COMMITTEE OF THE WHOLE MAY 29, 2006

SITE DEVELOPMENT FILE DA.06.022
ARCHDIOCESE OF TORONTO

Site Plan
 Lot 20,
 Concession 8
 APPLICANT:
 ARCHDIOCESE OF TORONTO

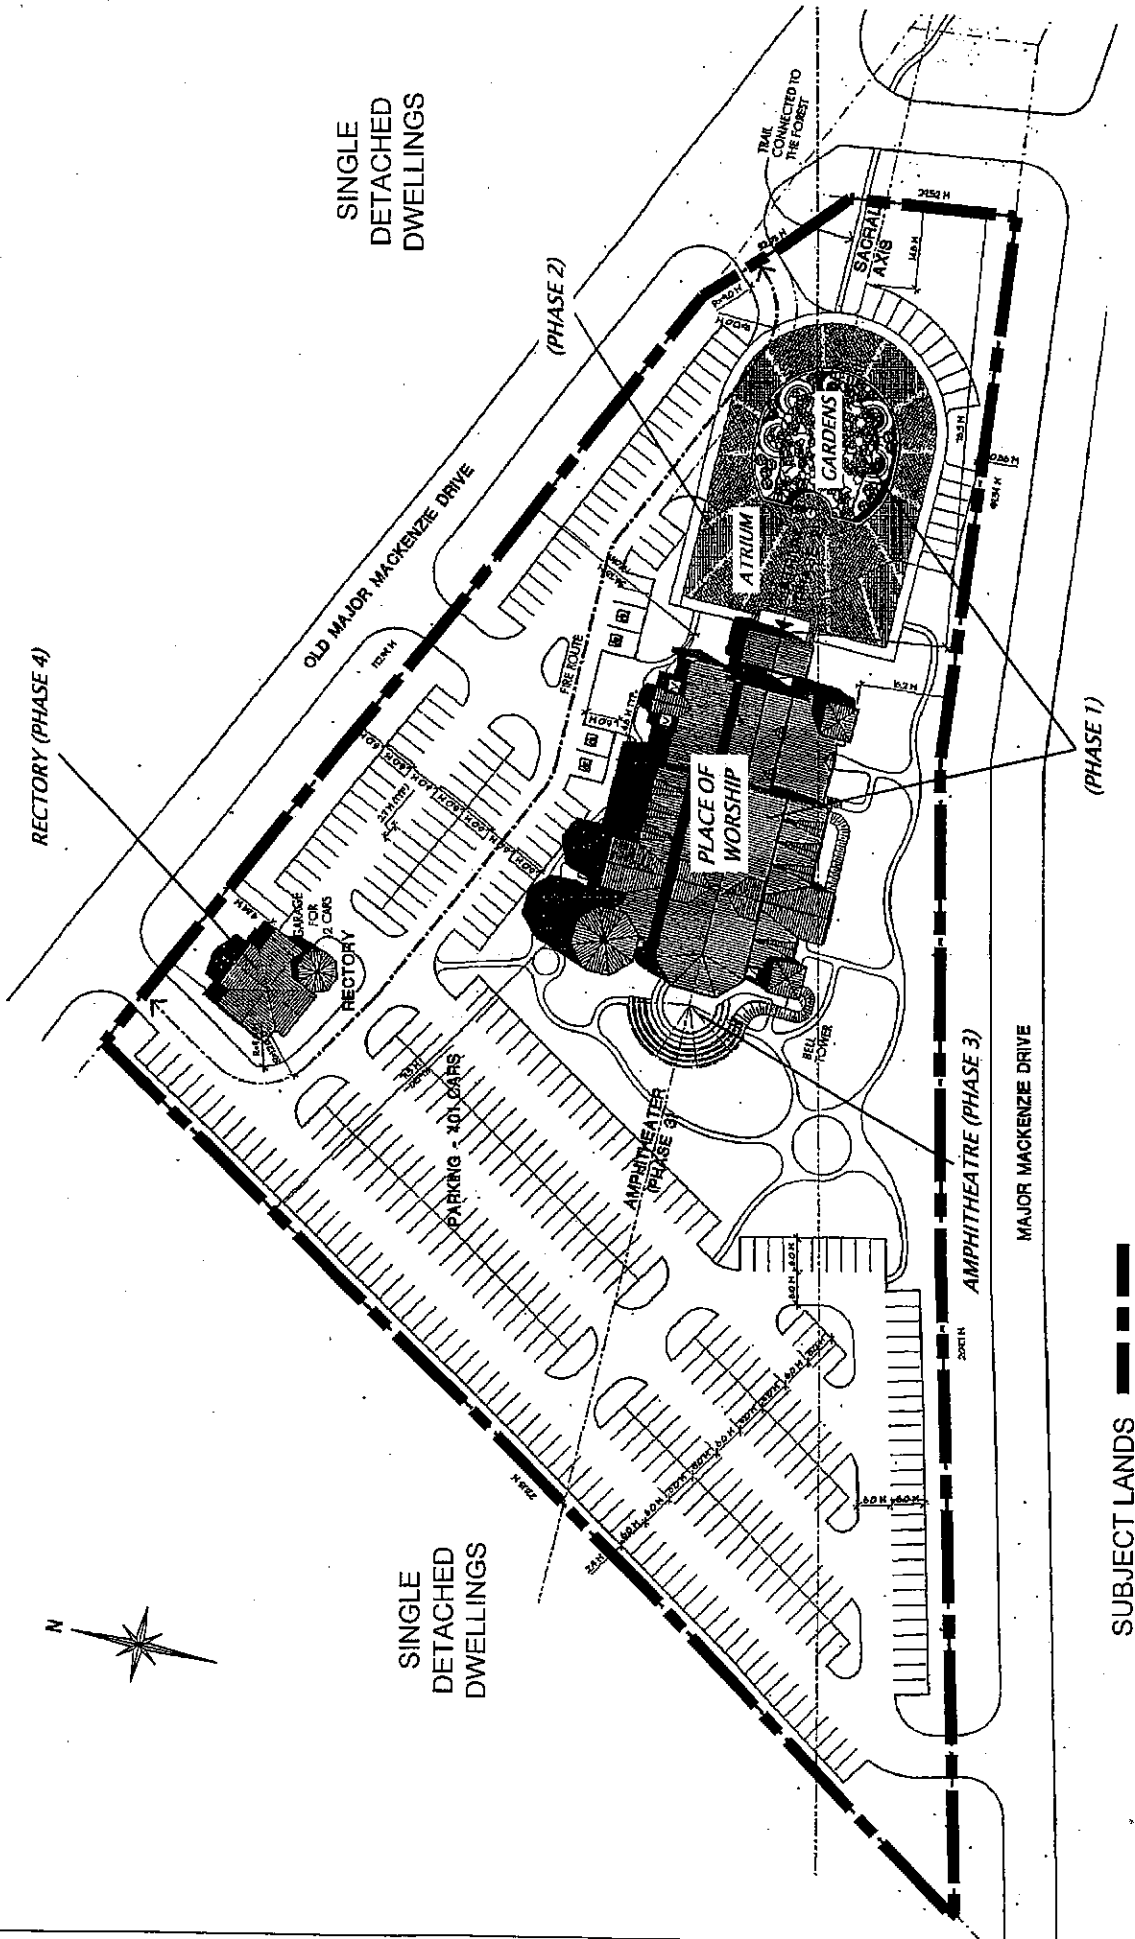
The proposed site plan is shown on Attachment #2 and illustrates a one-storey place of worship situated towards the centre of the triangular-shaped site. The site plan is proposed to be developed in four separate phases consisting of the place of worship and garden (Phase 1), the atrium, (Phase 2), outdoor amphitheatre (Phase 3), and rectory (Phase 4).

The site will be served by one 7.5m wide driveway access on Major Mackenzie Drive, and 3 accesses on Old Major Mackenzie Drive. The majority of the parking is situated at the west end of the site, with a total of 407 parking spaces, including 4 handicapped spaces. The proposed 'Place of Worship', amphitheatre and rectory uses require a total of 397 parking spaces, therefore the site will be developed with a surplus of 4 spaces. A circular garden is proposed at the front of the building, at the corner of Old Major Mackenzie Drive and Major Mackenzie Drive. A 2.4m wide landscape buffer area along the west property line separates the parking area from the adjacent residential development. The Development Planning Department will work with the applicant to ensure that this area is properly landscaped to achieve appropriate buffering from the

adjacent residential dwellings. A rectory is located at the northwest corner of the site adjacent to Old Major Mackenzie Drive, and an outdoor amphitheatre is proposed adjacent to the west side of the building. The site contains various pedestrian linkages from the parking areas to the building entrances, as well as to the amphitheatre. A pedestrian walkway is proposed to connect the building to Old Major Mackenzie Drive. The Development Planning Department requires additional pedestrian connections along Old Major Mackenzie Drive, and will work with the applicant to facilitate the additional linkages.

- a) that prior to the registration of the site plan agreement:
 - i) the final site plan, building elevations, landscaping plan, and signage plan, shall be approved by the Development Planning Department;

- ii) the final site grading and servicing plan, stormwater management report, soils/geotechnical report, access, parking and on-site vehicular circulation, shall be approved by the Engineering Department;

Landscape Plan

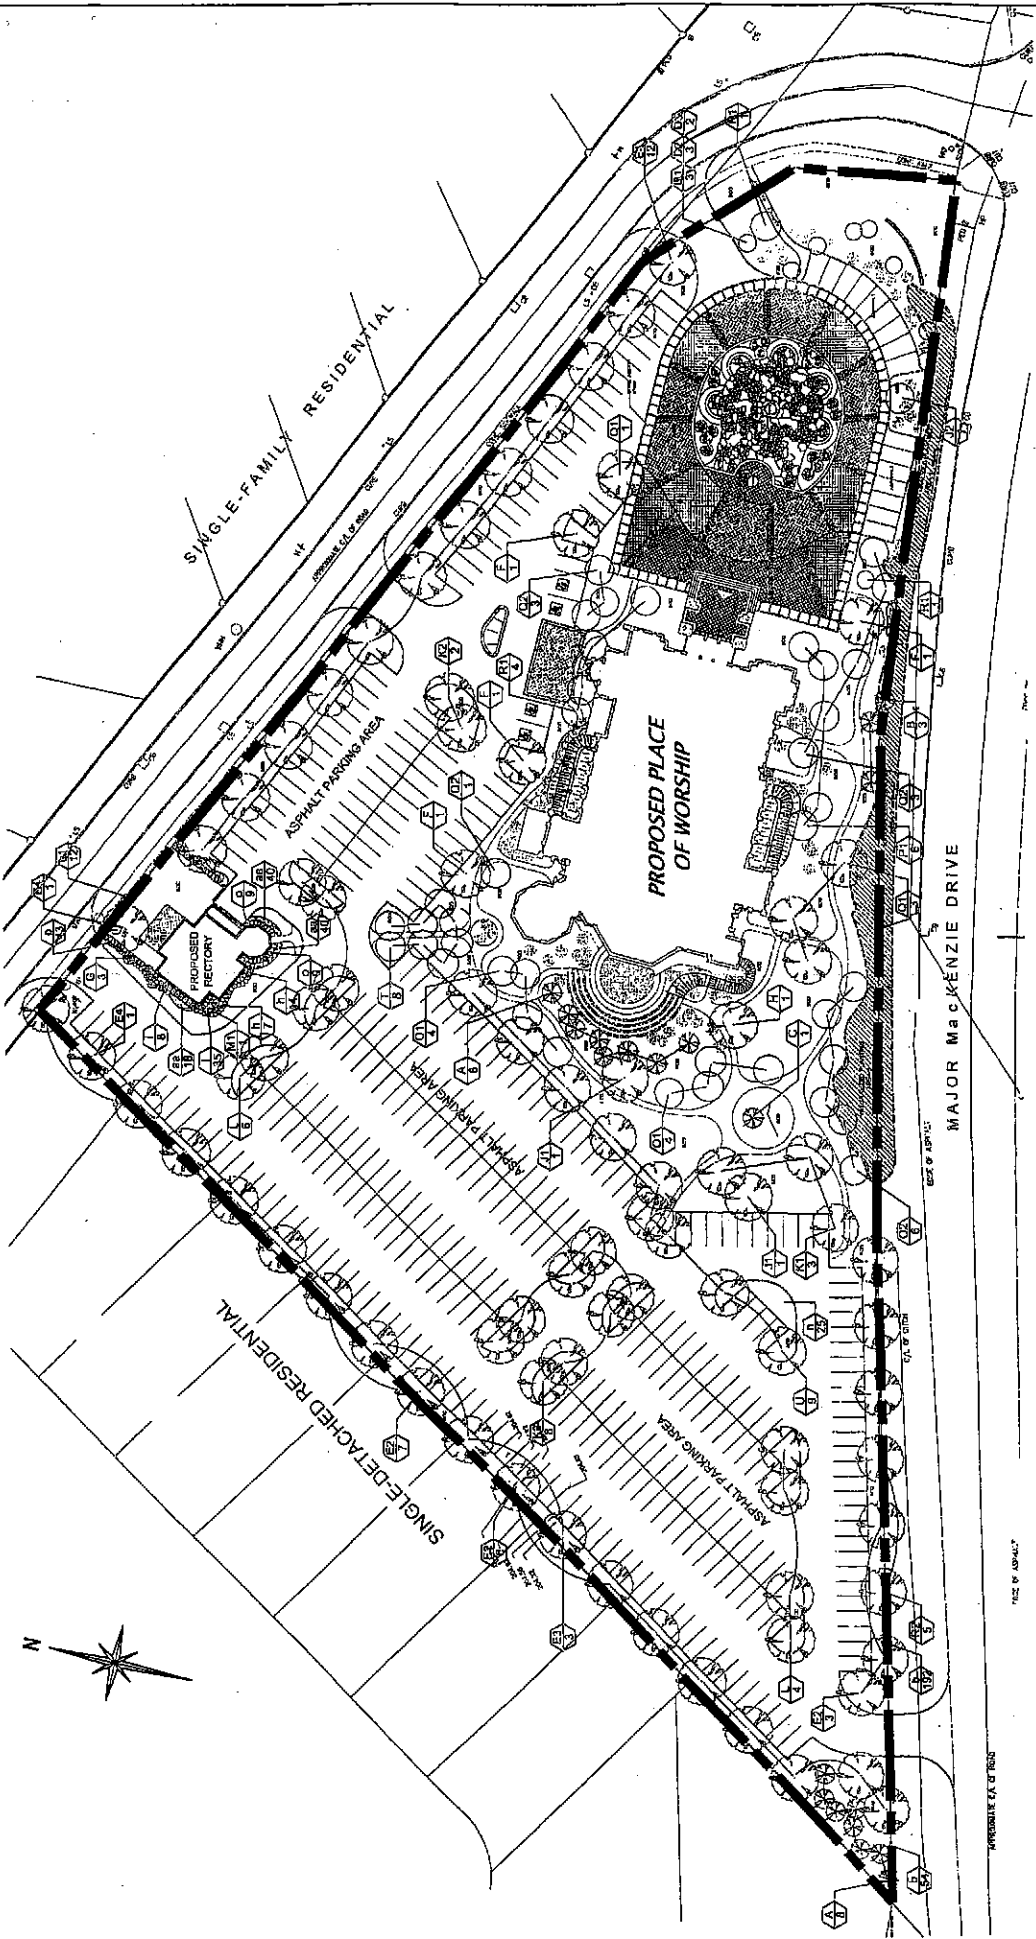
The landscape plan as shown on Attachment #3 includes a variety of deciduous and coniferous trees and shrubs throughout the site, and around the perimeter the property. A 2.4m wide landscape strip is provided along the west property line, a 6.0m landscape strip adjacent to Old Major Mackenzie Drive, and a landscape strip between 0.24m and 3m is provided adjacent to Major Mackenzie Drive. A phased re-naturalization of the southern limits of the site along Major Mackenzie Drive is proposed. Details on the re-naturalization phasing are required to determine its appropriateness at this location. Regional approval is also required for the re-naturalization

proposed on the Regional lands abutting Major Mackenzie Drive. The Development Planning Department will work with the Owner and the Region to achieve the re-naturalization in this area

A circular garden is proposed at the main entrance of the building at the Old Major Mackenzie Drive and Major Mackenzie Drive location, which includes flag-stone paving, circular seating areas and various trees, shrubs and perennials. A circular driveway consisting of unit pavers is provided around the garden. Unit pavers are also provided at the main entrance and atrium, as well as the at the north elevation, facing Old Major Mackenzie Drive. A wall feature is proposed for the corner of Major Mackenzie Drive and Old Major Mackenzie Drive. Additional information on the wall details as well as any additional landscape treatment at this street corner is required prior to final approval.

The final landscape plan, including detail drawings and a landscape cost estimate must be approved to the satisfaction of the Development Planning Department.
